Errata

MVPX2ERR/D
Rev. D, 3/2002

MVP X2 Multiprocessor
Evaluation System
Errata

Errata 46: CPU2 Power Supply Fix

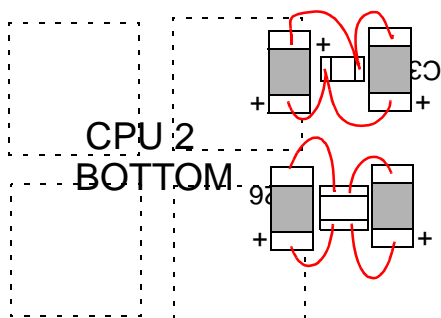
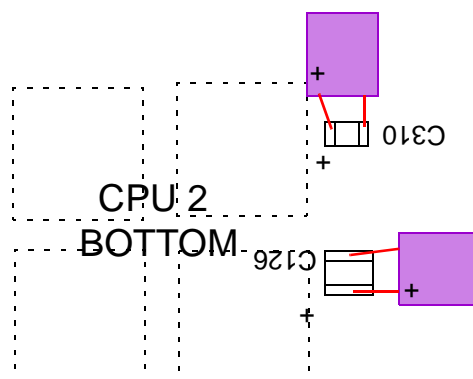
Lack of bypass capacitors on one side of CPU #2 limits Fmax.

1. Add capacitors across C126 and C310 on the bottom of the board beneath U2. Connect either:

A) two 600-800 uF 6-10V OSCON capacitors, or

B) four 470 uF 6-10V tantalum capacitors.

2) Connect as shown for either type, observing capacitor polarity.

A) C126 ground is to the right/toward the PCI slots.

B) C310 ground is towards the bottom (toward U1).
